## REPORT | ADMINISTRATIVE REPORT TO COUNCIL

**PRESENTED:** December 15, 2020  
**REPORT:** 20-127  
**FROM:** Resort Experience  
**FILE:** RZ1165, BYLAW 2298  
**SUBJECT:** RZ1165 – CHEAKAMUS CROSSING PHASE 2 – ZONING AMENDMENT BYLAW (CHEAKAMUS CROSSING PHASE 2 PARCELIZATION) NO. 2298, 2020, FIRST AND SECOND READING

RZ 001165  
2nd Review  
1340 Mount Fee Road  
Cheakamus Crossing  
Neighbourhood Phase 2  
"Upper Lands" Rezoning  
Parcelization Plans

# PARCEL B/C

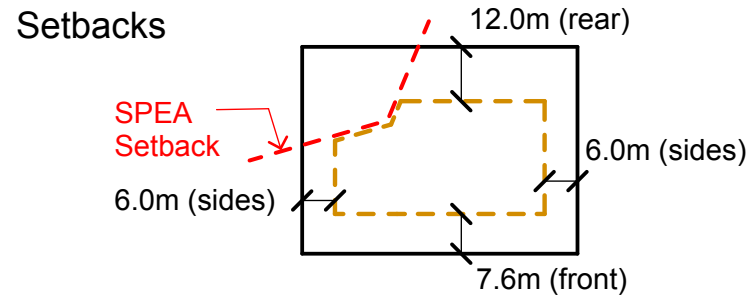
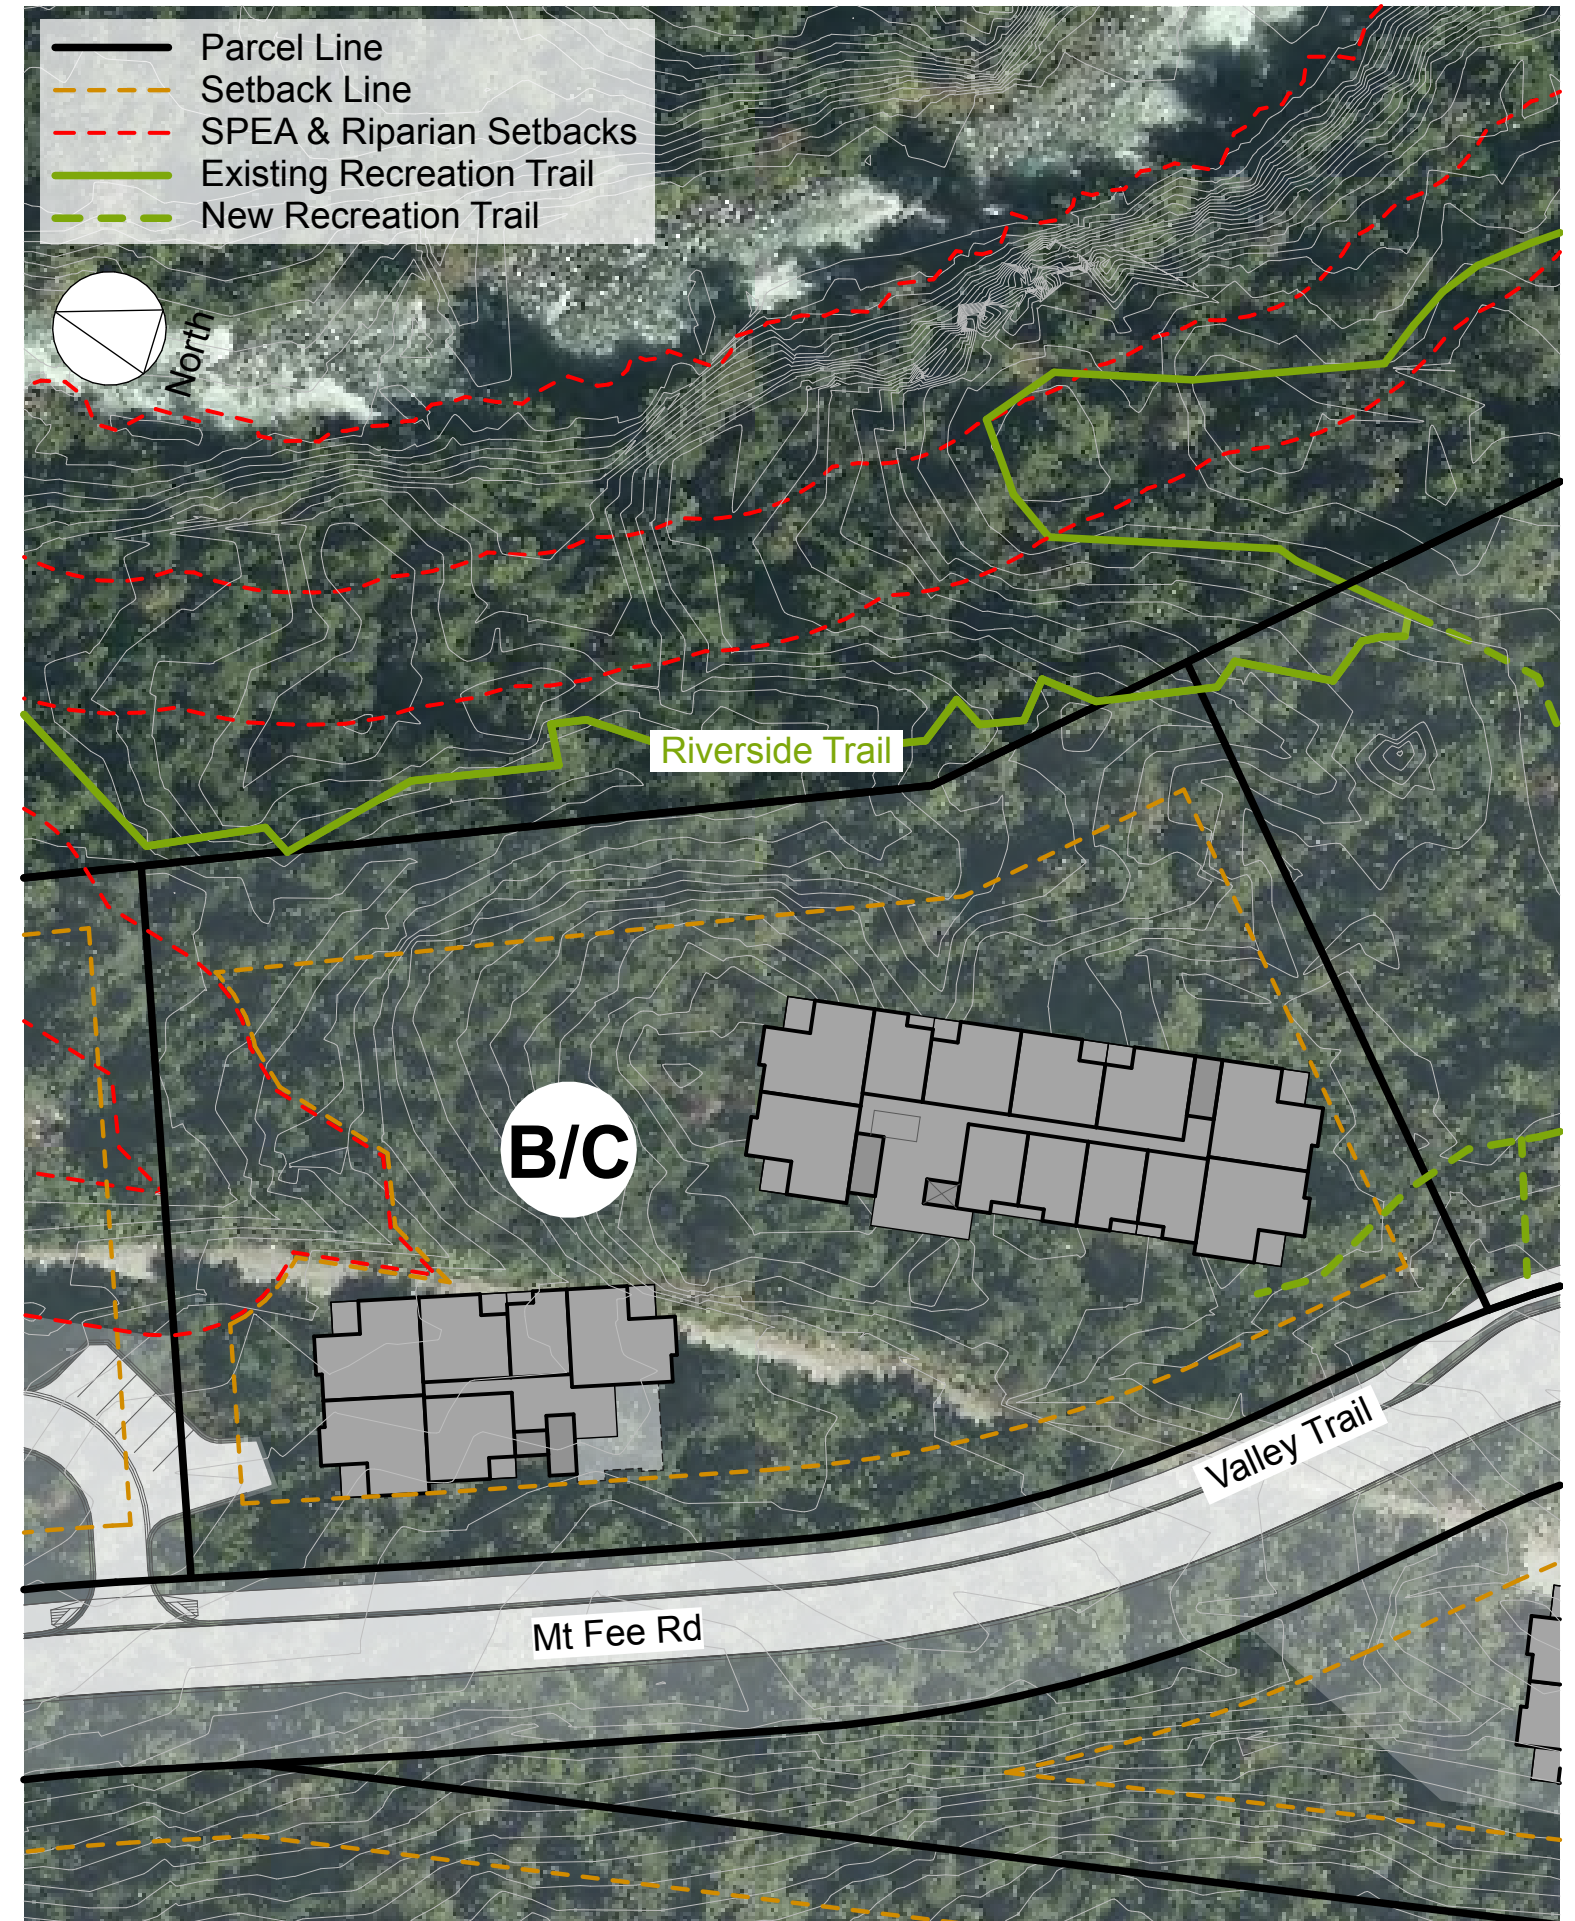
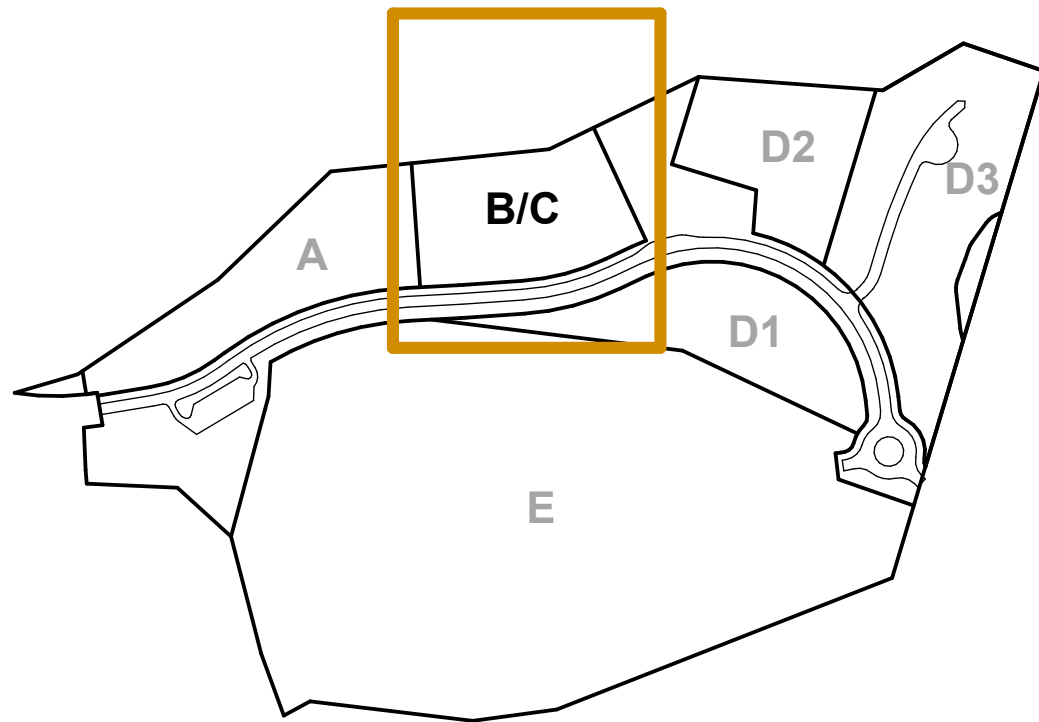
1. Panel generally supports the changes made to this site; consider flexibility in the zoning to support more density.
2. Panel noted that there may be an opportunity to increase the floor area through an L shape plan and make the building form more useful.

# PARCEL D1

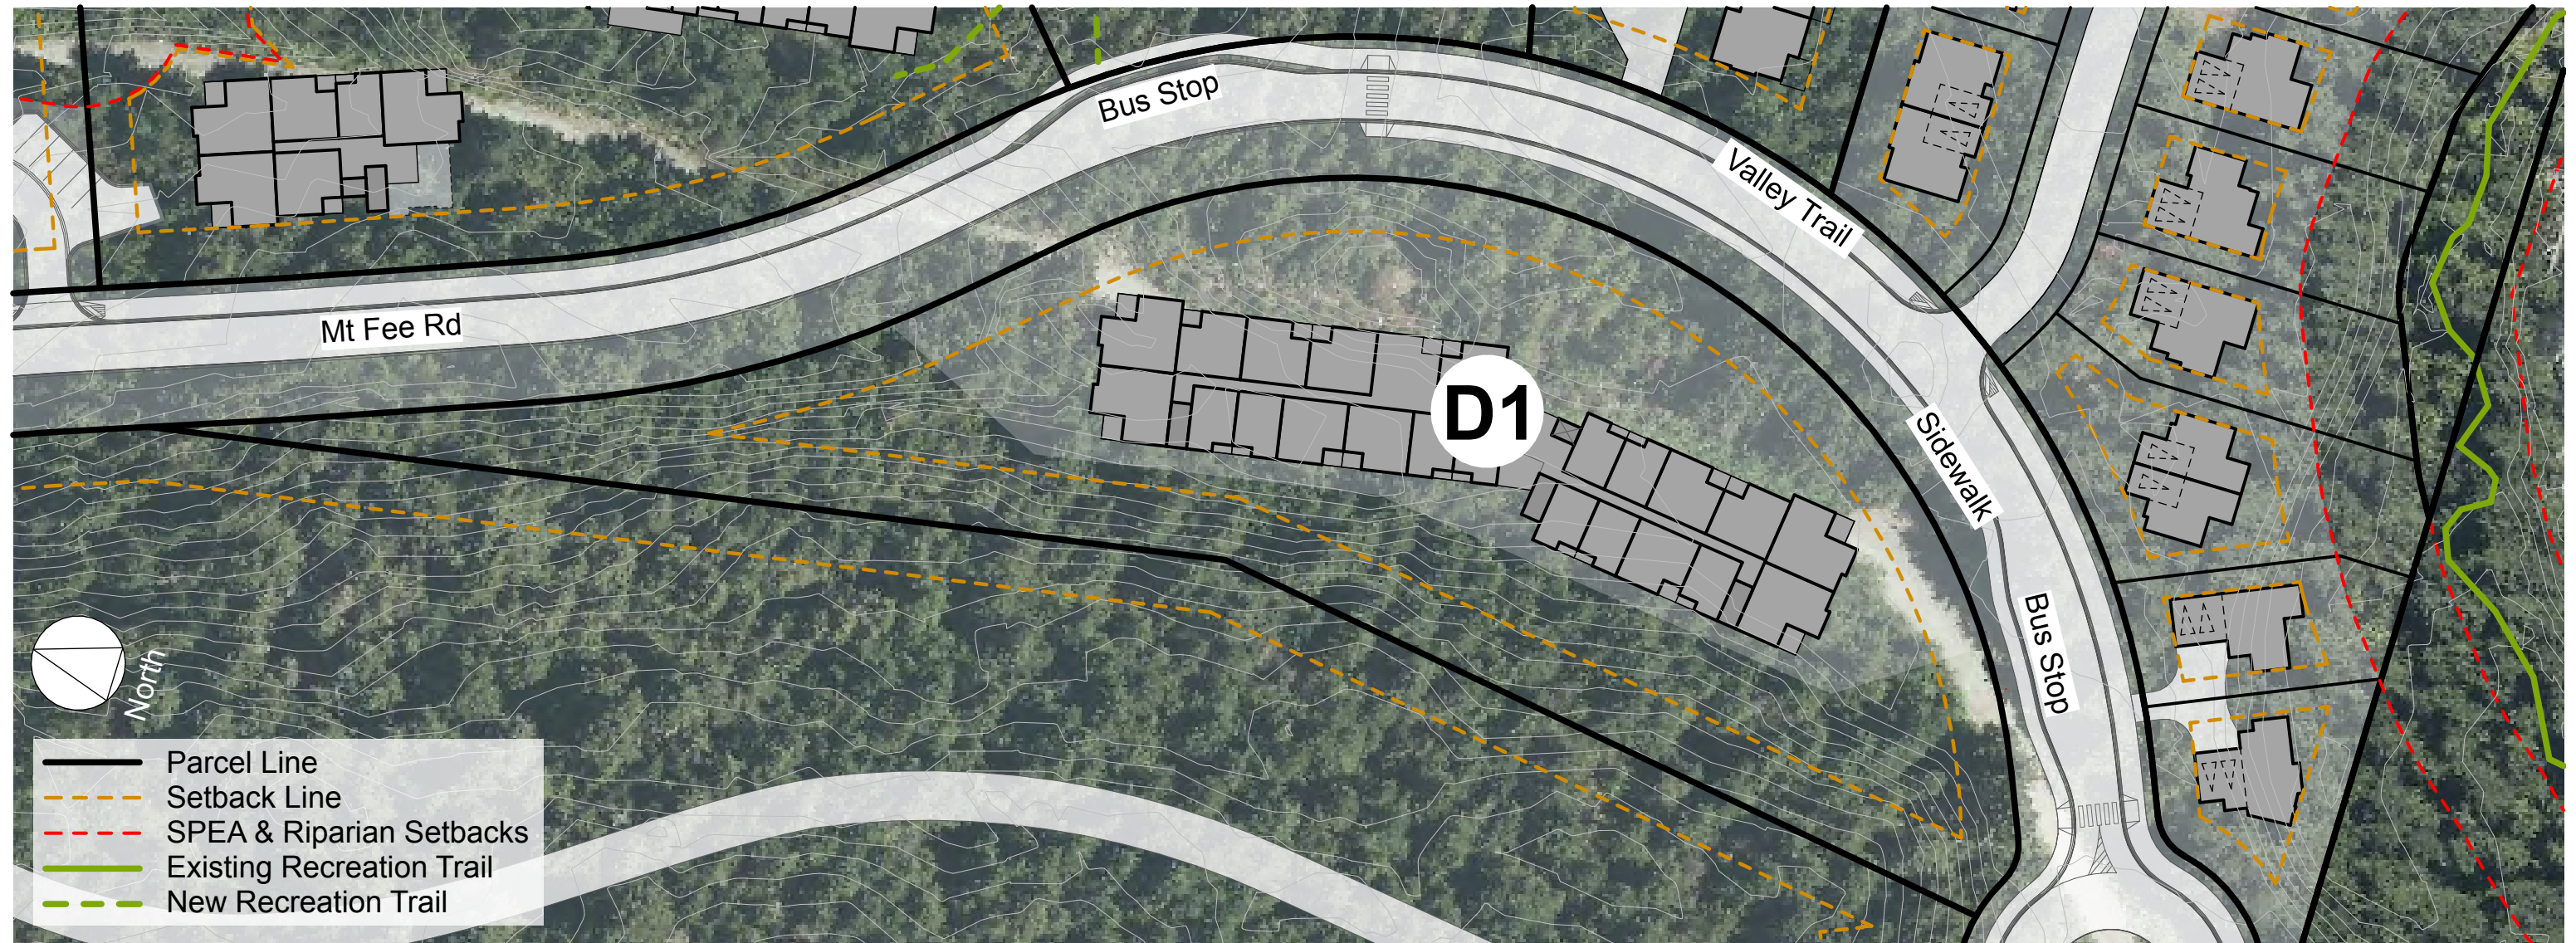
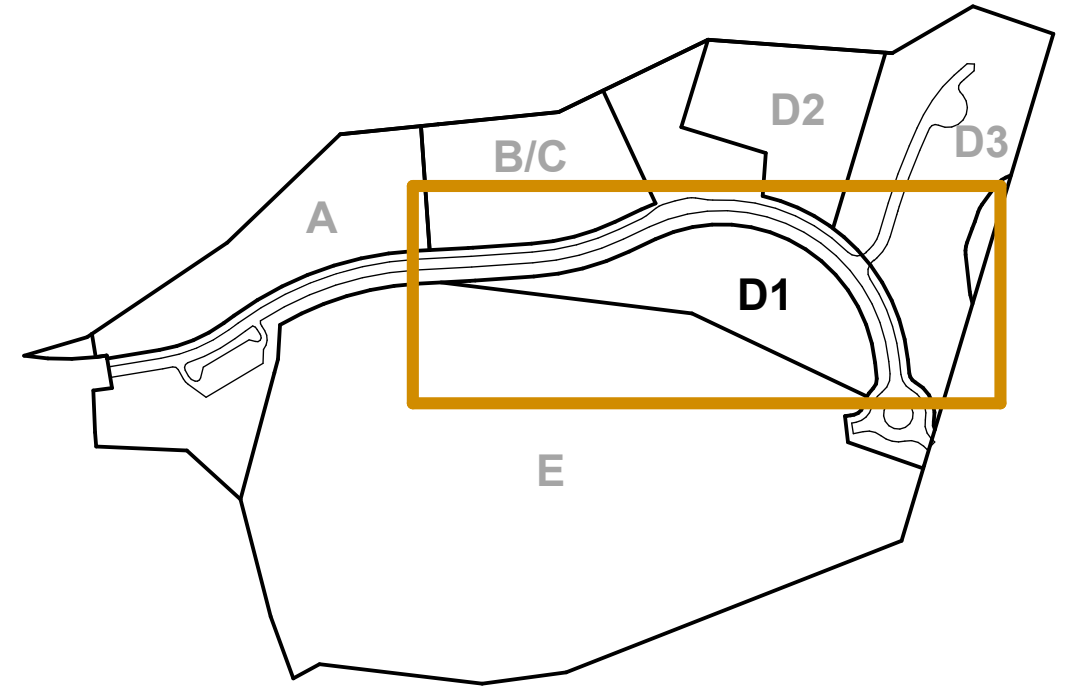
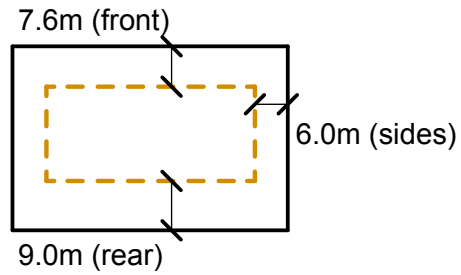
1. Consider integrating into the zoning stepping of the building mass from three storeys to four storeys.
2. Panel notes that there is ample room on the side yards to provide for stepping the building, particularly the end that is facing the single family and duplex residences in area D3.

**That** the Advisory Design Panel supports the apartment development concept for site D1 subject to the provision of building articulation; consider stepping from four storeys to three storeys at the ends, especially where it faces the lower density residential development in area D3. Provide a landscape buffer along Mount Fee Road with flexibility for access and other common space considerations.
